CITY OF KETCHUM, IDAHO

DATE: March 14, 2024

ADDENDUM NO. 2

Idaho Project No. A022(210)
SH-75, Main St, Ketchum
Blaine County, Key No. 22210

ENGLISH	
COUNTY	BLAINE
KEY NUMBER	22210
SHEET	121 OF 176

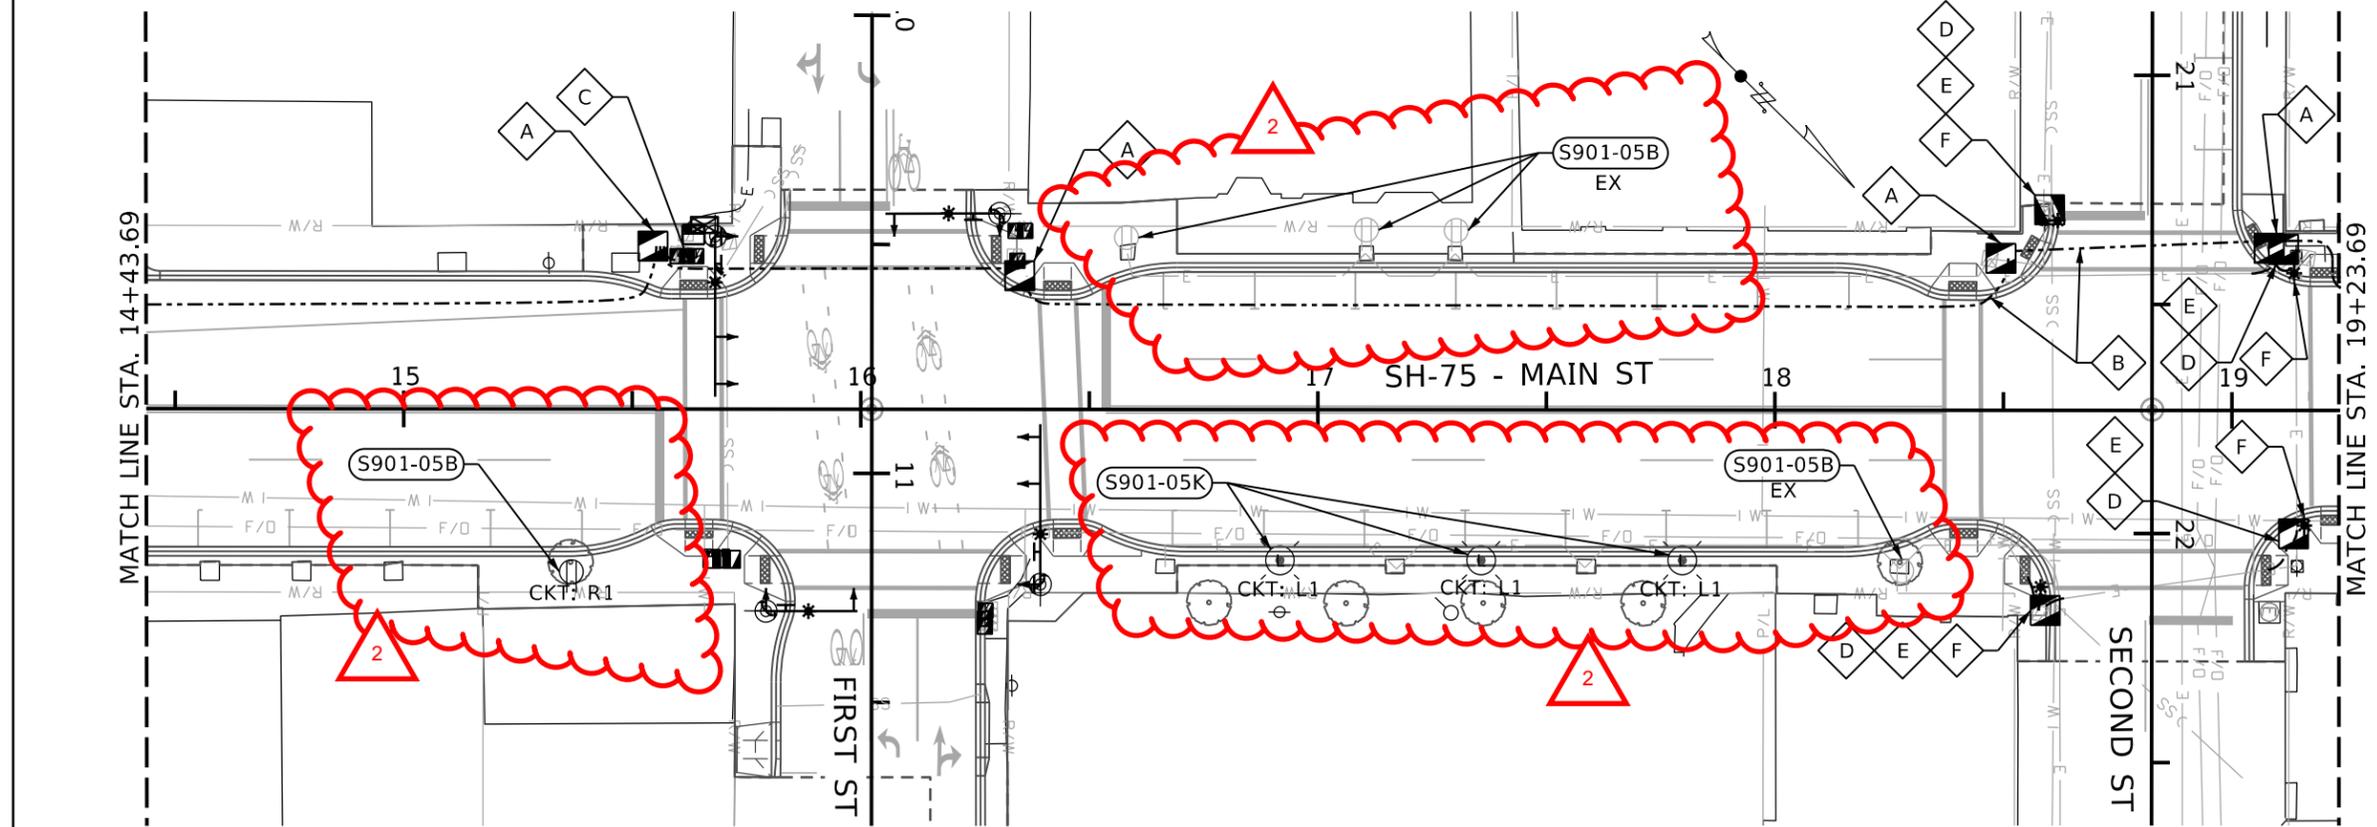
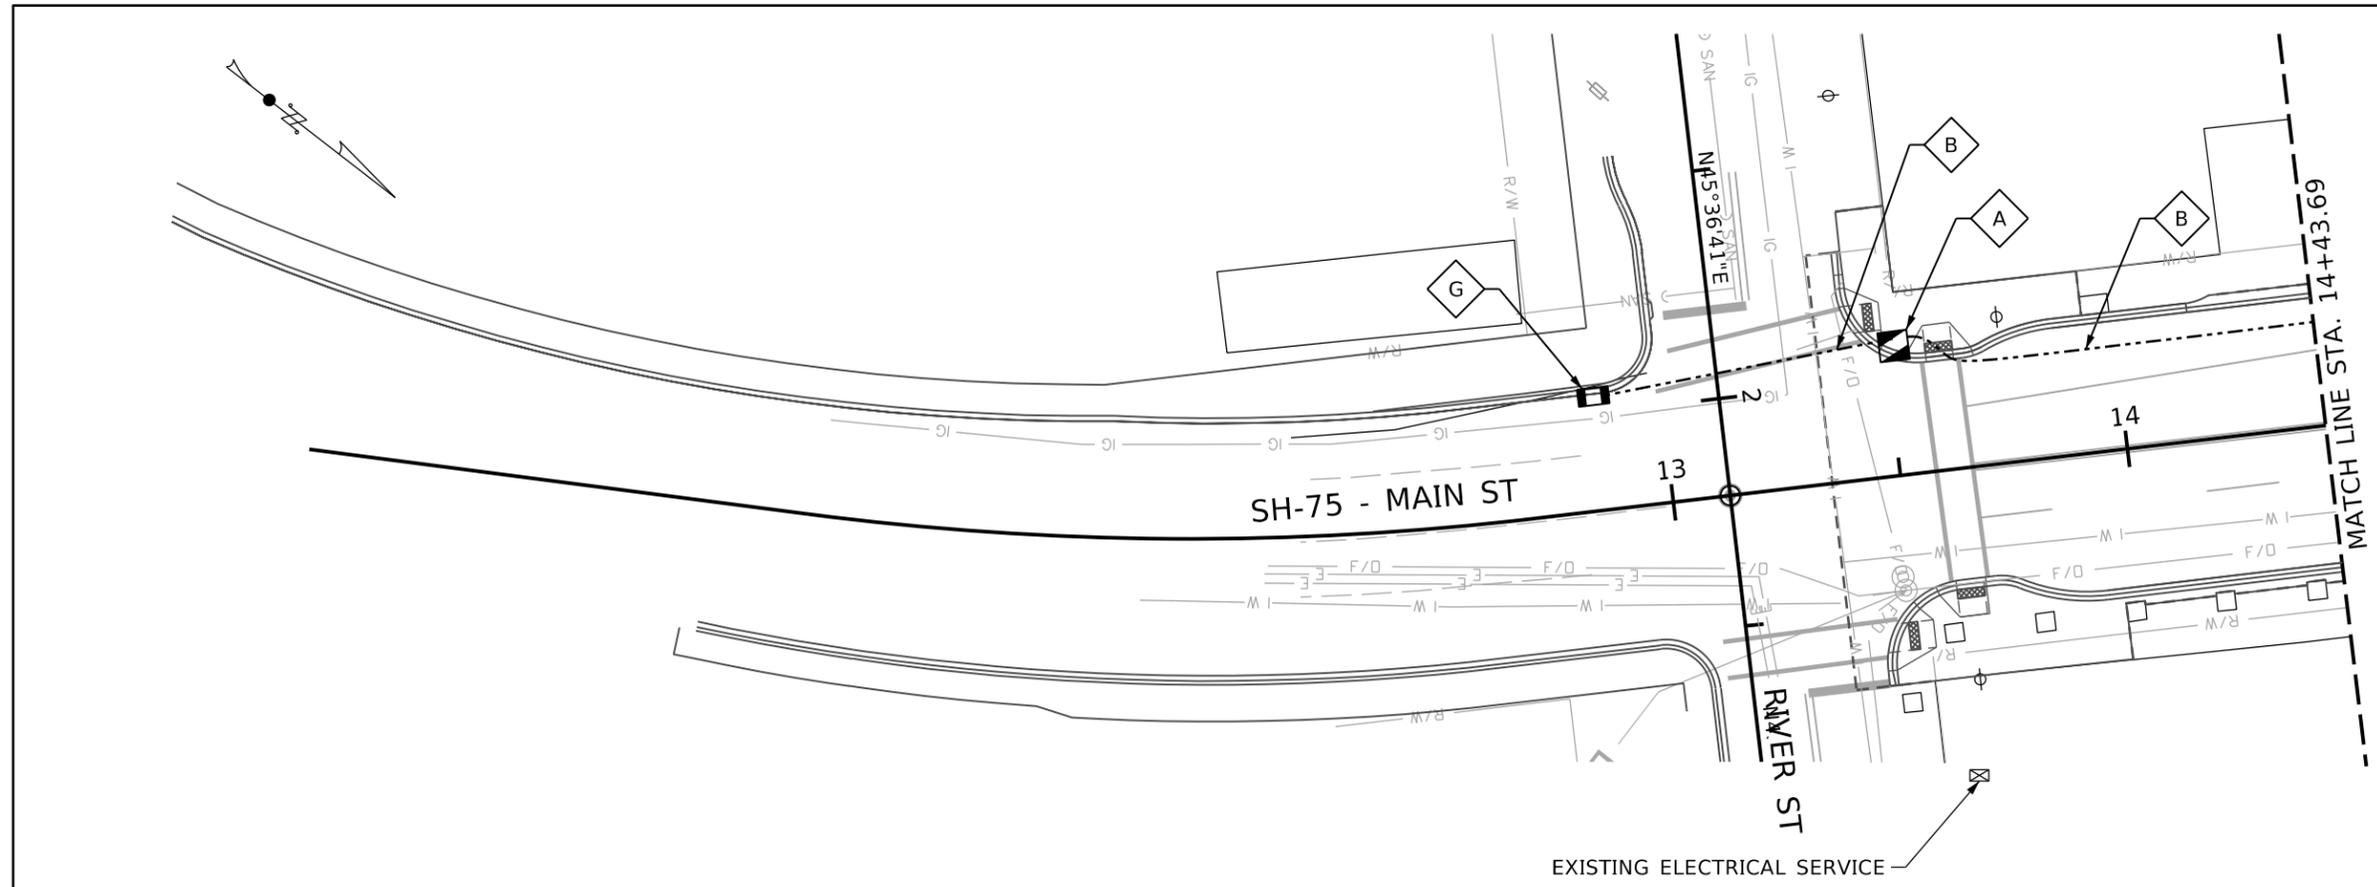
- REPLACE plan sheets 121, 122, 123 make changes as indicated in attached modified sheets representing more detail on the new electrical work to service trees and pedestrian poles.
- REPLACE on plan sheets 128, 134, 140 (TRAFFIC SIGNAL MATERIALS LIST)
